### MINERALS PROGRAM INSPECTION REPORT PHONE: (303) 866-3567

<b>MINE NAME:</b> Portland Limestone Quarry	<b>MINE/PROSPECTING ID#:</b> M-1977-344	<b>MINERAL:</b> Limestone (general)	<b>COUNTY:</b> Fremont
<b>INSPECTION TYPE:</b> Monitoring	<b>INSPECTOR(S):</b> Timothy Cazier, P.E.	<b>INSP. DATE:</b> July 16, 2020	<b>INSP. TIME:</b> 09:30
<b>OPERATOR:</b> Holcim (US) Inc.	<b>OPERATOR REPRESENTATIVE:</b> Julio Villon & Tom Newman	<b>TYPE OF OPERATION:</b> 112c - Construction Regular Operation

**Subject: Detailed Facilities Inventory for Portland Cement Plant and Quarry, DRMS  
Permit #M-1977-344 ✓**

FACILITY MAP  
PORTLAND PLANT  
FLORENCE, COLORADO  
PORTLAND PLANT - FLORENCE COLORADO

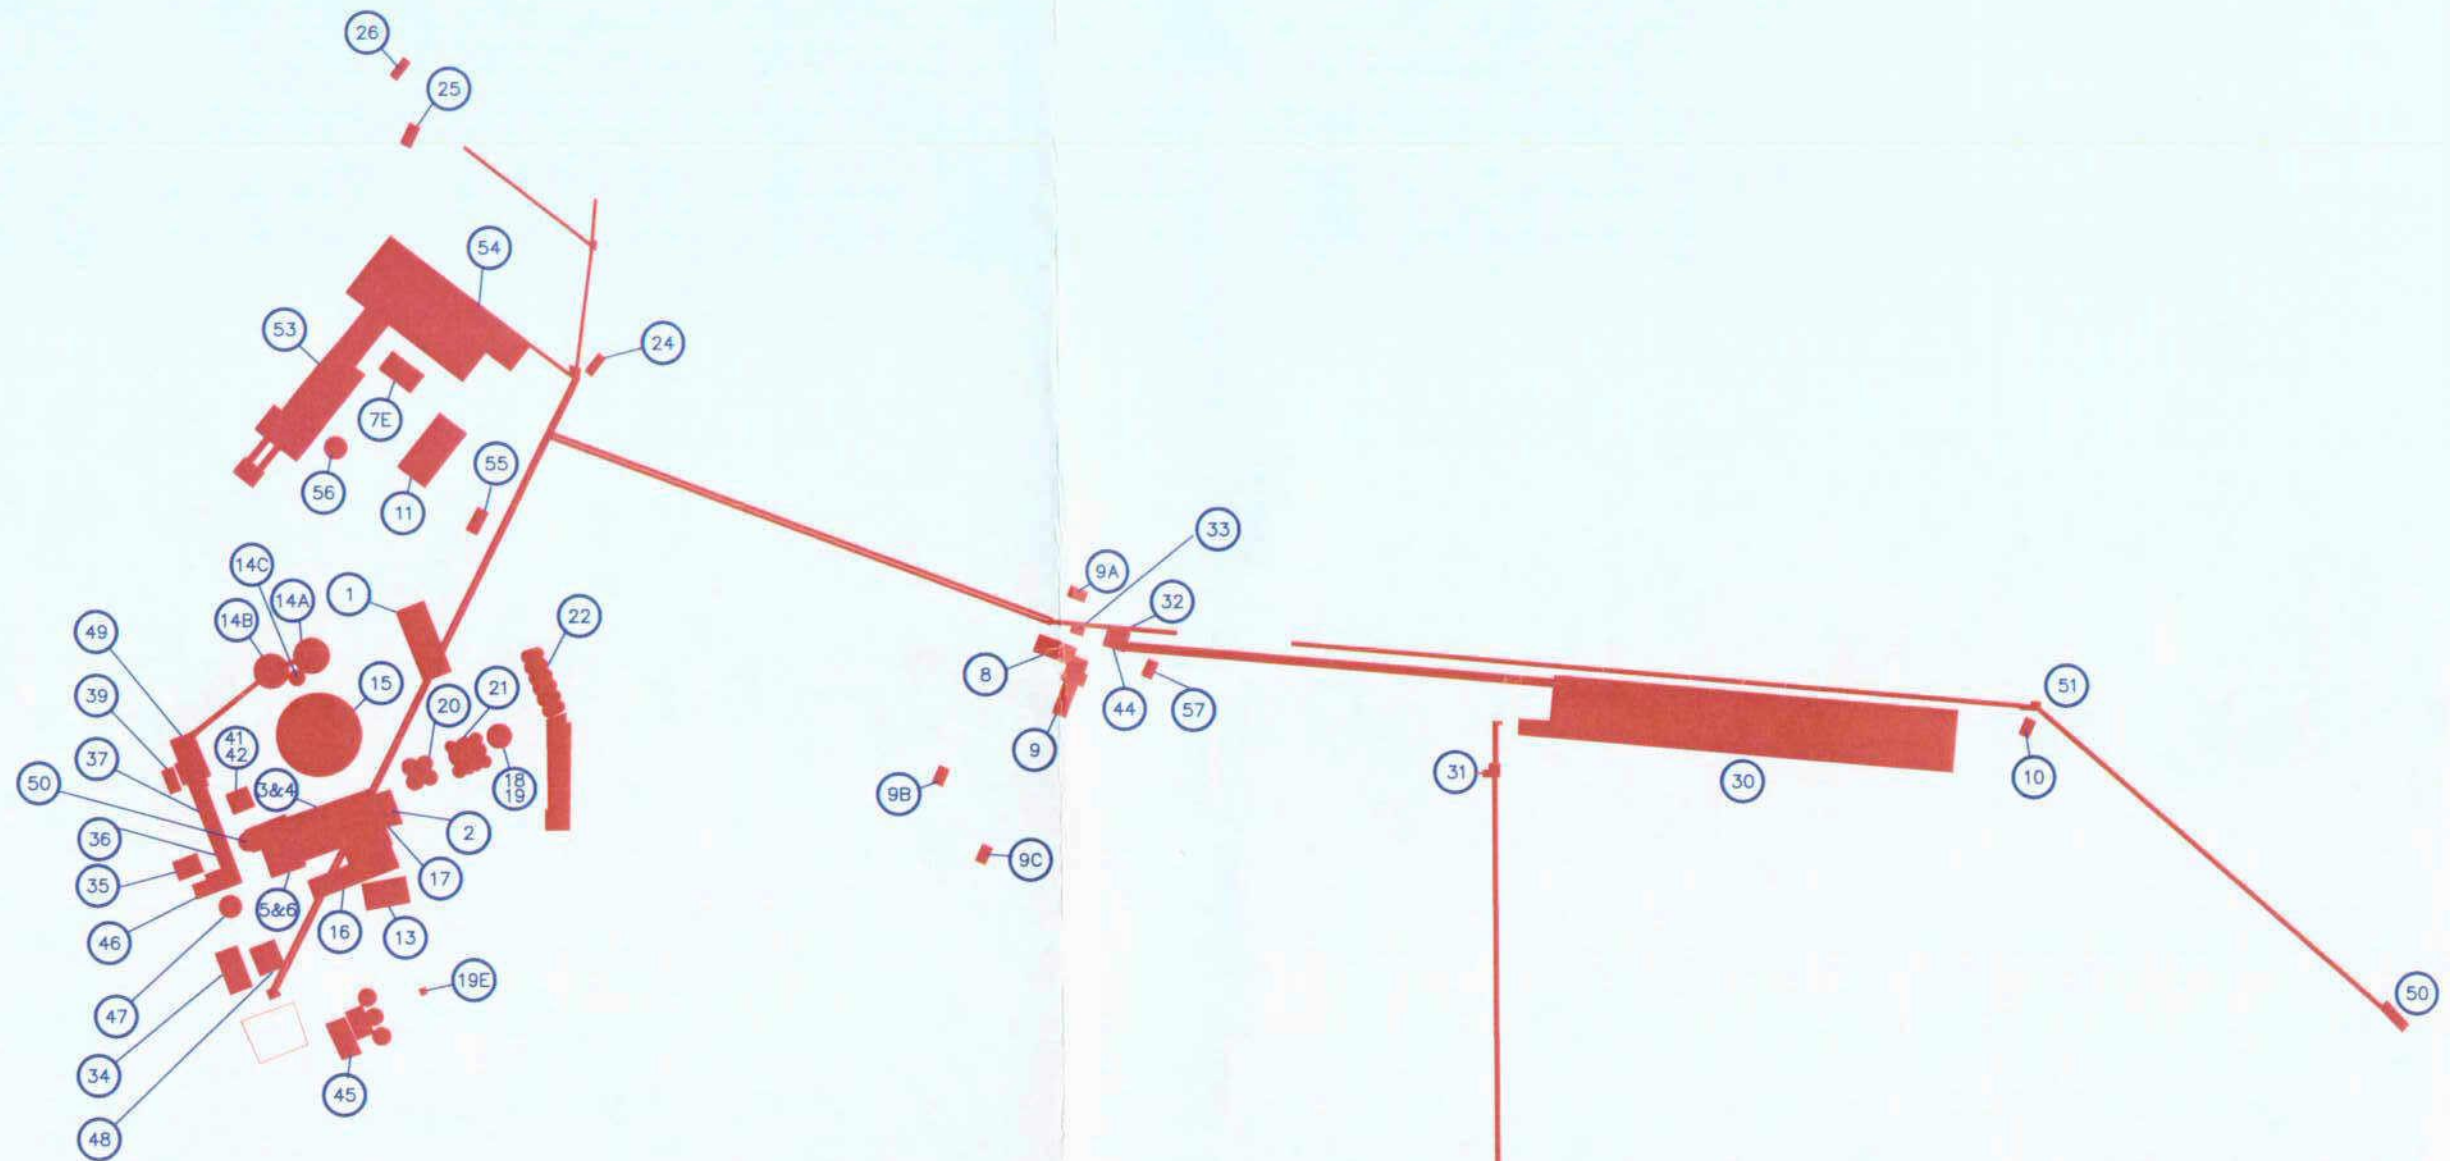
**PROBLEM/POSSIBLE VIOLATION:** Problem: The appropriate financial warranty related to demolition of the cement plant facilities and other site buildings cannot be determined by the Division from available information. Rule 6.4.12(1) requires "All information necessary to calculate the costs of reclamation must be submitted and broken down into the various major phases of reclamation." This information is to be provided by the Operator and must be sufficient to calculate the cost of reclamation that would be incurred by the state.

**CORRECTIVE ACTIONS:** Provide the Division with cement plant and mine site building information necessary for demolition cost estimates to include: location, square footage, construction materials, building volume and foundation construction information by the corrective action due date.

Financial Warranty: A thorough review of the permit confirmed the cement production plant is still part of the permit, contrary to a previous understanding. As such, the \$5,268,550 bond is likely insufficient to cover demolition of approximately 60 structures as well as the required mine site reclamation. During the inspection, the need to keep the plant site in the permit was discussed. Site representatives said it would be a management decision. Subsequent to the inspection, the DRMS was informed Holcim wishes to keep the plant in the permit, rather than release it as a separate industrial facility. The DRMS subsequently began updating the financial warranty estimate based on the facility inventory received in January 2009 (see **Attachment A**). Based on Google Earth mage comparisons with the map provided to supplement the inventory list, it was determined that some of the 62 structures in the 2009 inventory appear to have been demolished, while some structures observed in Google Earth are not in the inventory. While the 2009 inventory provided building material information and square footage, the DRMS also requires building volume for an accurate estimate of demolition costs. A sample building demolition cost estimate worksheet is included as **Attachment B** for your reference. **The lack of a complete structure inventory, including building volumes is cited as a problem on page 1 of this report.**
